THE COST OF COMPROMISE

Response to Revised Application Materials

B-1C Rezoning Request — 473 South Main Street, Harrisonburg, Virginia

“The Link” — TCP Link Harrisonburg, LLC / Timberwolf Capital Partners

Figure 2. Eastbound on Paul St. at Mason St.

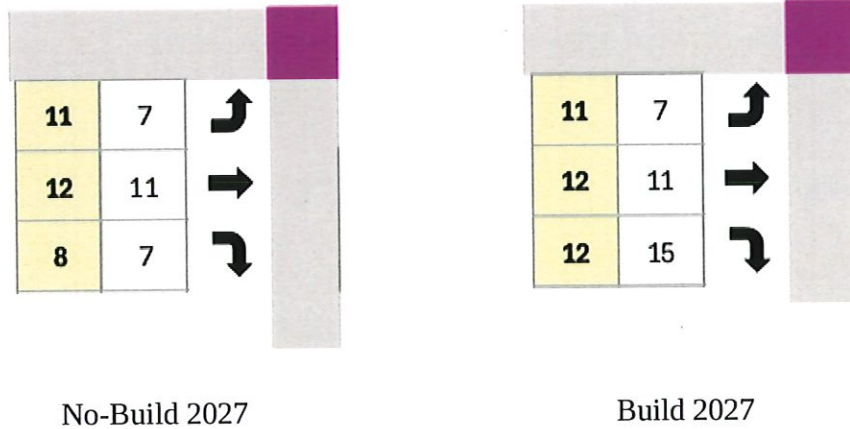
Second, the thru and left turn movements in the "Build 2027" model eastbound on Paul St. at Mason St. are also identical to those in the "No-Build 2027" model.

This ignores the fact that some percentage of the trips from the proposed project to East Campus, the Walmart Shopping Center, and E. Market St. shopping will use Paul St. to get to MLK Jr. Way. In addition, the right turn movements are assumed to increase by 4 during the peak and 12 during the off-peak. This means that the model assumes very few trips from the proposed project to West Campus will use Paul St. to get to S. Mason St.

Figure 3. Westbound on E. Grattan St. at Ss Main St.

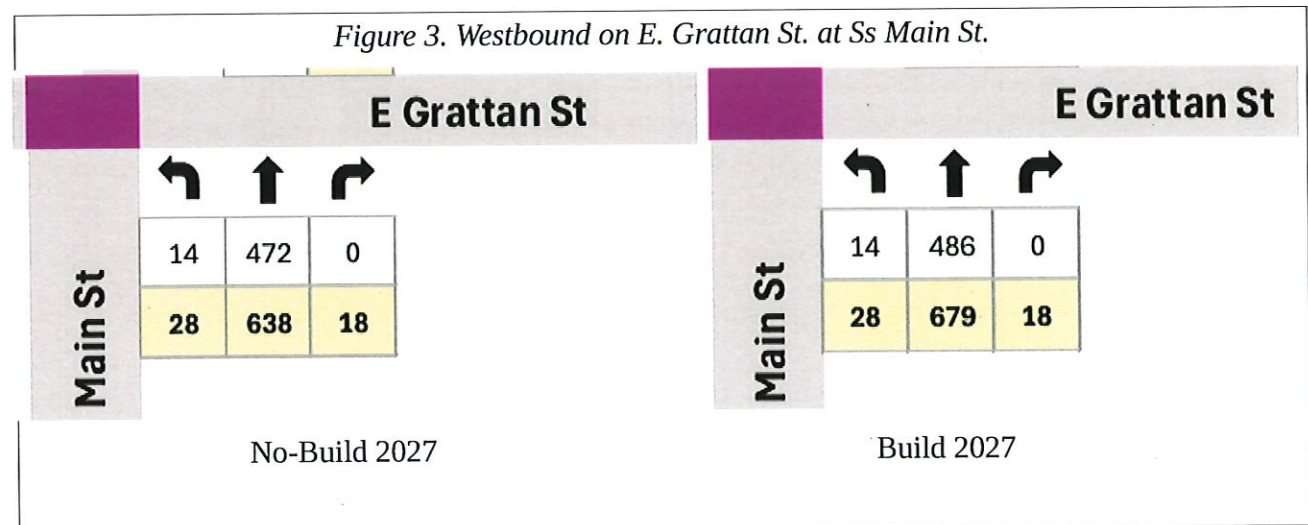
Third, the turning movements in the "Build 2027" model westbound on E. Grattan St. at S. Main St. are identical to those in the "No-Build 2027" model.

It is not clear what the origins and destinations of the current trips are, but it seems very unlikely that the number won't increase as a result of the proposed project

Map 1. Some Alternative Paths/Routes from The Link to Target

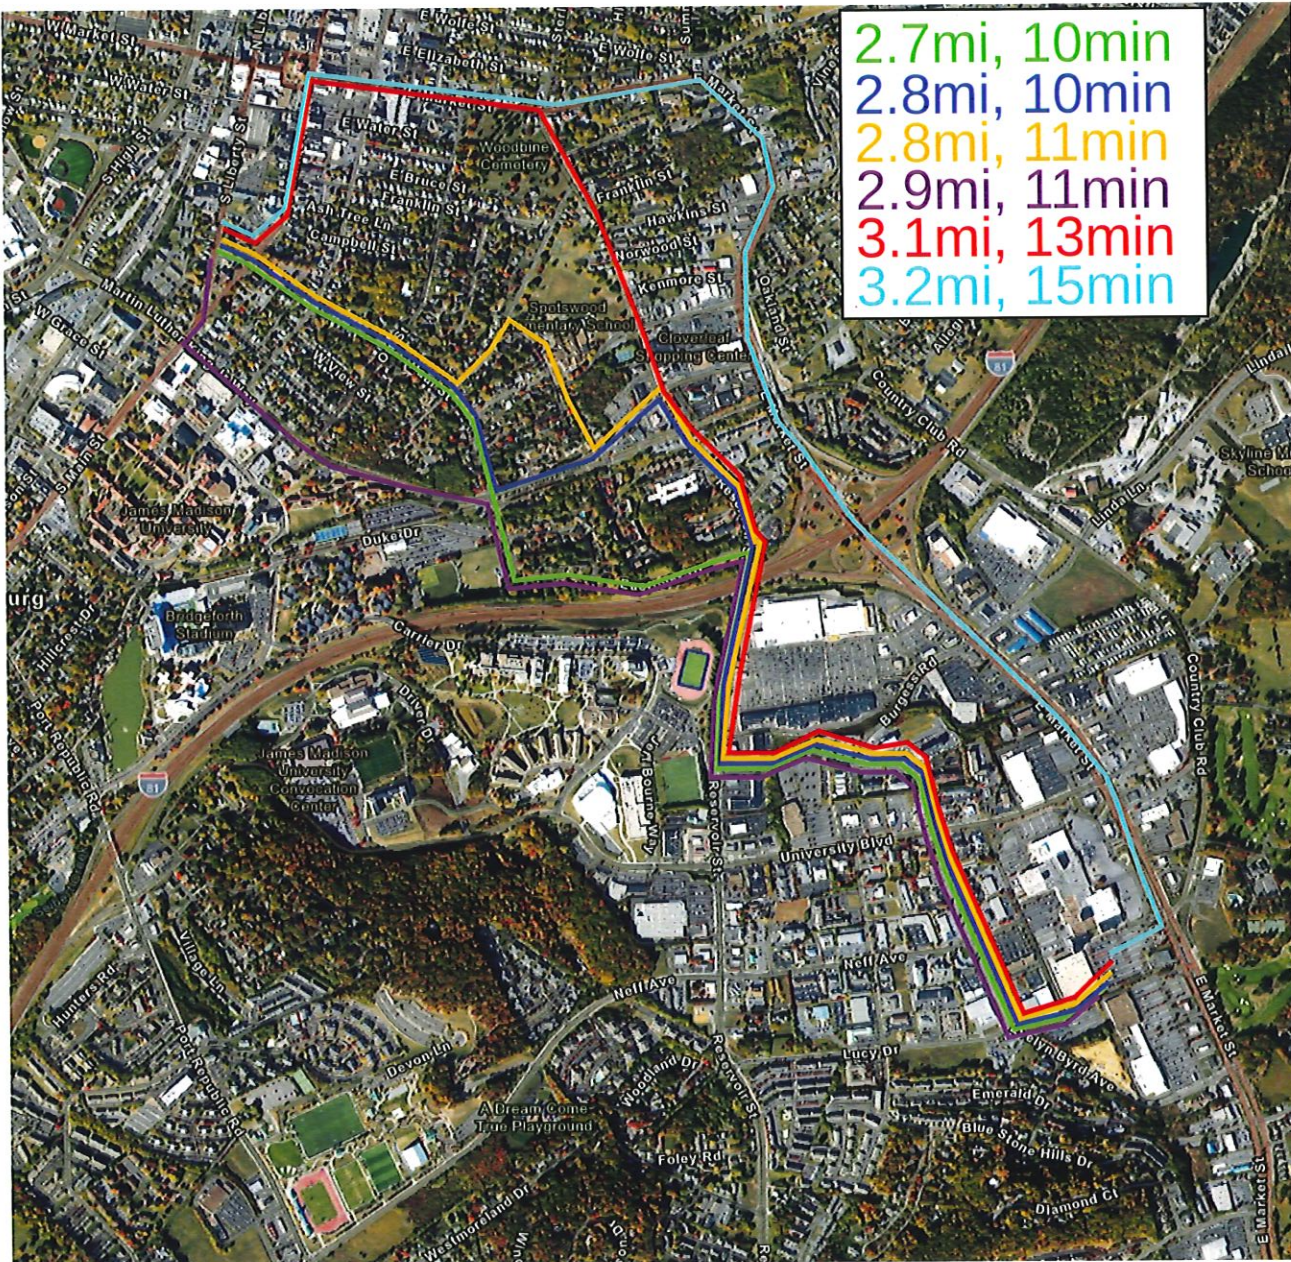
These shortcomings are, in large part because the original TIA (dated March 2025) did not take route/path choice decisions into account at all. As an example, the following figure illustrates the approximate lengths and travel times from The Link Apartments to one likely destination, Target.

As shown in Map 1, **there are many paths/routes from The Link Apartments to Target that have very similar lengths and travel times, and hence are likely to be considered viable alternatives.**

Map 3. Overflow On-Street Parking Near The Link

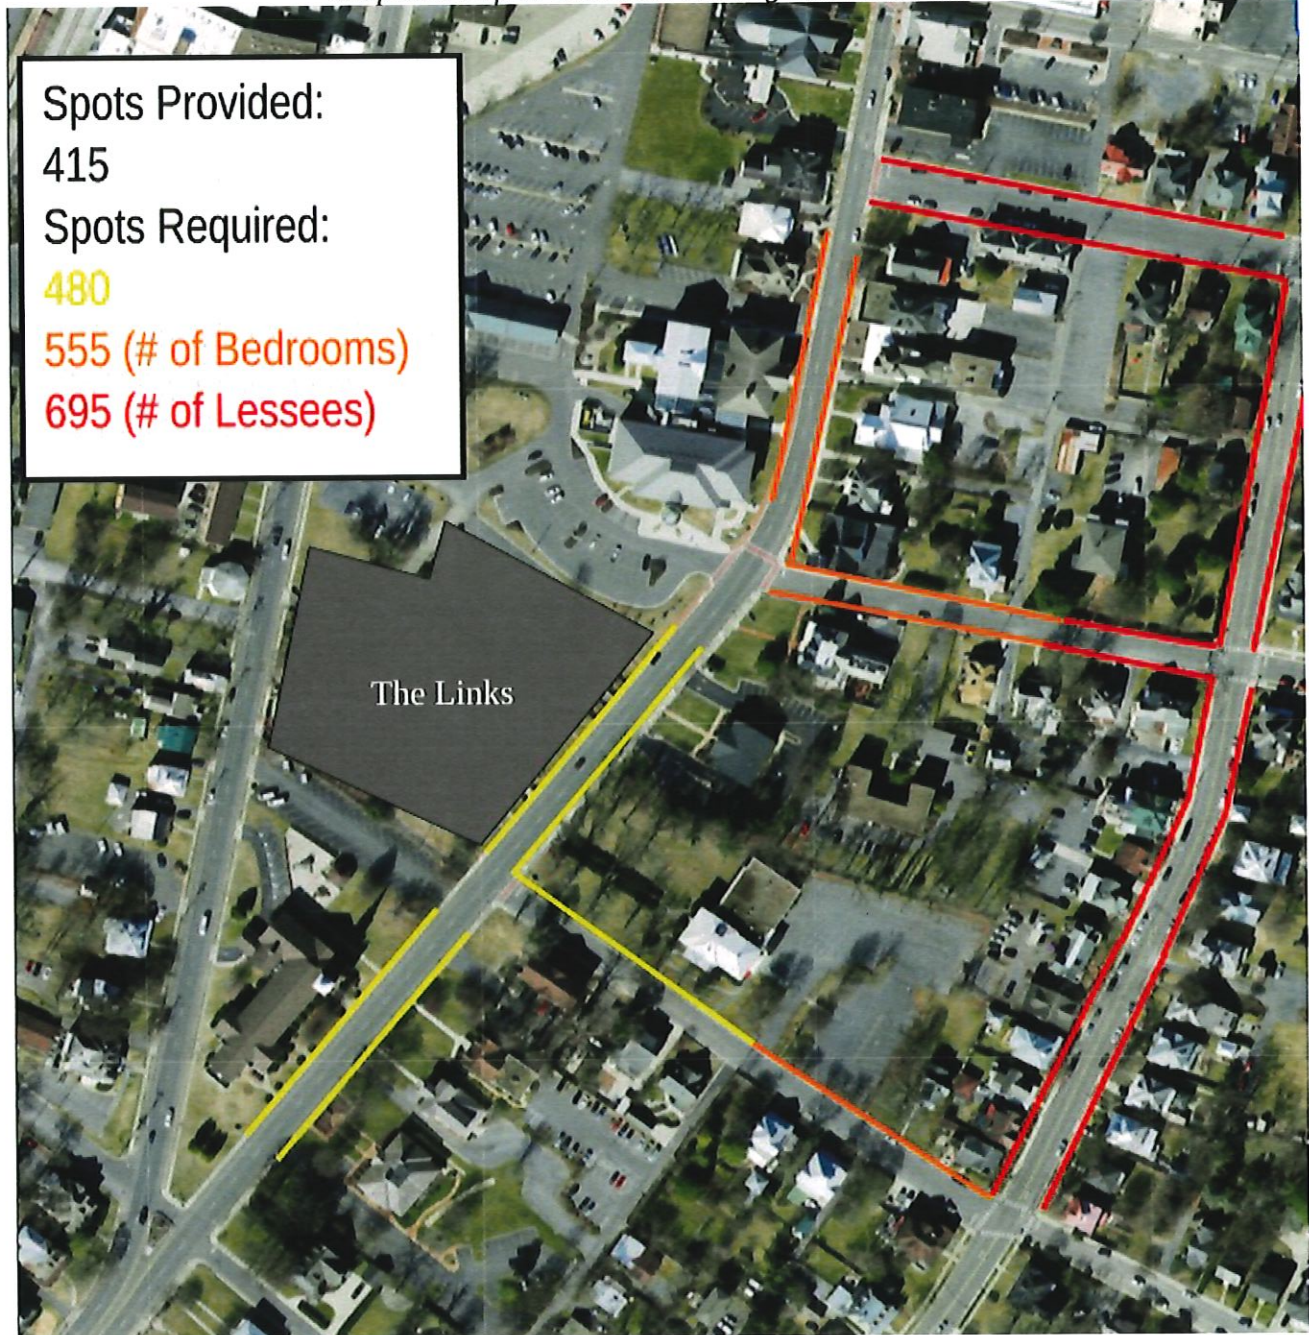
If, in fact, all 480 spaces are required by residents, the closest 65 on-street spaces are on Main St. and Paul St. (as shown in yellow on Map 3). If, instead, there is one car per bedroom (as is possible in a complex in which the residents are college students and/or unmarried professionals), then 555 spaces will be required. The next closest spaces are farther north on Main St., and on Campbell St. (as shown in orange on Map 3). If, in fact, there is one car per lessee, then 695 spaces will be required (with the next closest spaces to the complex shown in red on Map 3).

Of course, many of these spaces are already used by existing residents and shoppers. Hence, either the existing residents and shoppers will be displaced, or the residents of the new complex will have to park farther away. **It is also important to note that the amount of traffic generated by people circling for a space is likely to be significant.**

Photo 1. Overhead View of Paul St. and S. Main St.

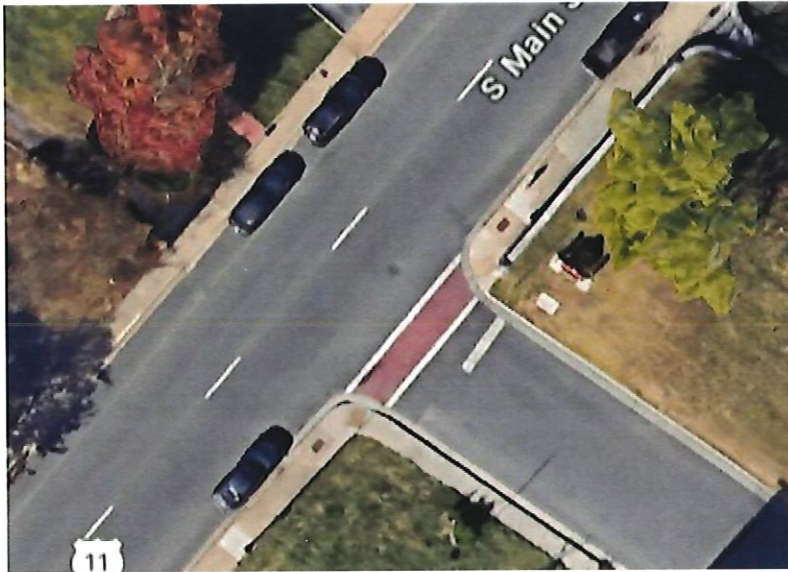
At the location of the proposed extension, Paul St. will go from a wide segment (on the east side of S. Main St.) to a narrow segment (on the west side of S. Main St), and the two segments may not align well. This is illustrated in Photo 1 and Photo 2.

Photo 3. Overhead View of Paul St. and S. Mason St.

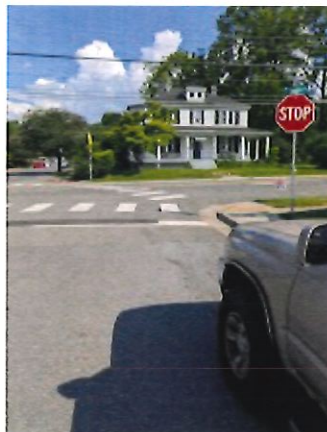
Similarly, at the intersection of Paul St. and S. Mason St., Paul St. goes from a wide segment (to the west of S. Mason St.) to a narrow segment that contains traffic calming measures, and the two segments do not align on the south side of the intersection. This is illustrated in Photo 3 and Photo 4.

*Photo 4. The Intersection of Paul St. and S. Mason St.
taken from the Eastbound Curb*

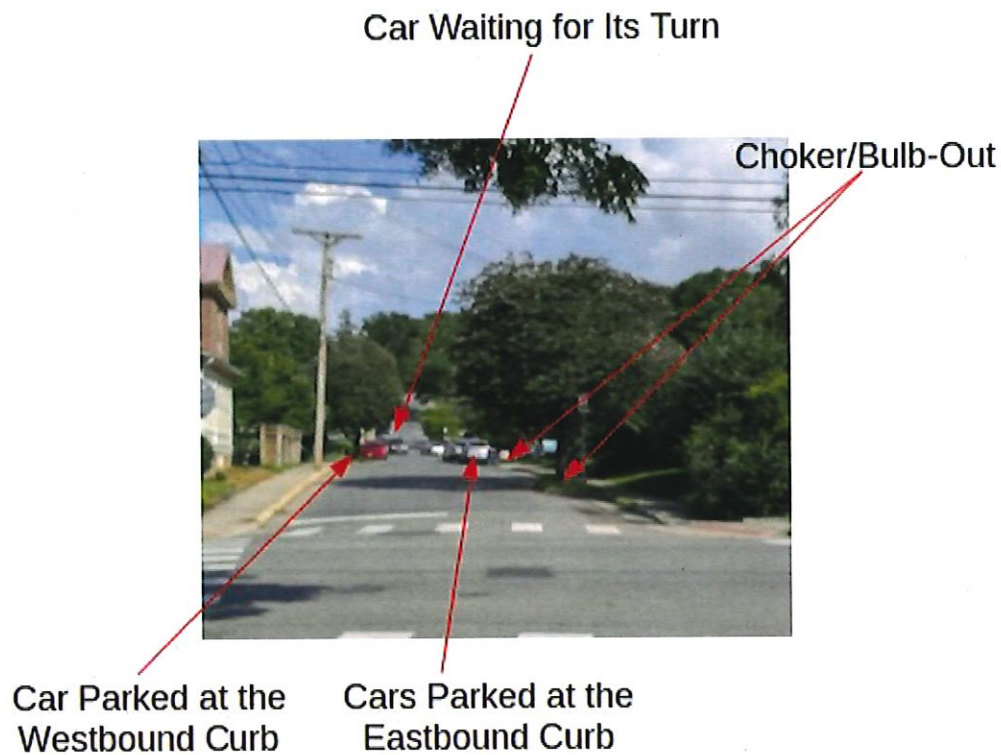
S. Mason St. is very difficult to cross as a result of the geometry. This difficulty is exacerbated by the fact that there are chokers on the narrow segment and by the fact that cars are always parked on both sides of the street. The result is that the effective width of this segment of Paul St. is only 15 feet. Hence, cars must take turns using this segment. This is illustrated in Photo 5.

Photo 6. Paul St. and Ott St.

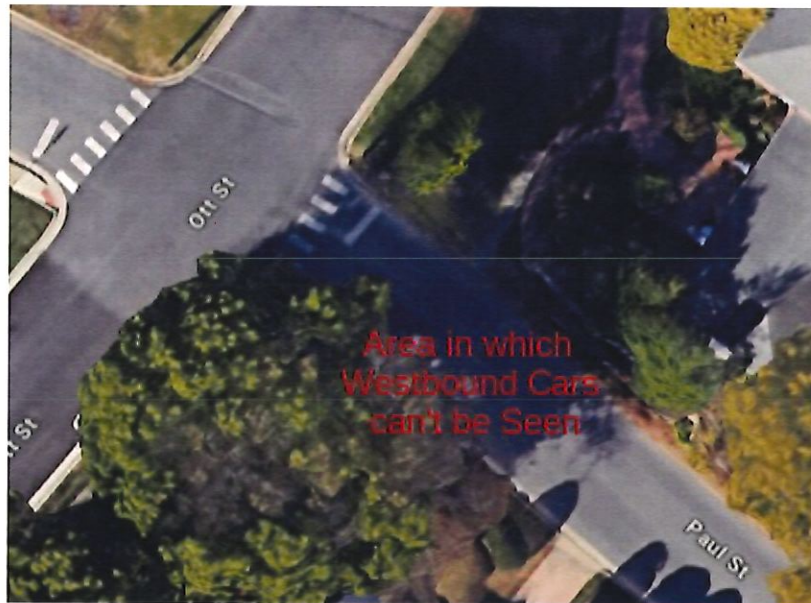
Finally, though it varies, the grade of Paul St. is quite steep in places. This is particularly true in and around the intersection with Ott St. This causes a large number of problems when the road is slick, but also causes problems under normal conditions. In particular, when crossing Ott St. on Paul St. in the eastbound direction, there is a fairly large area in which it is impossible to see oncoming cars. This is illustrated in Photo 6.
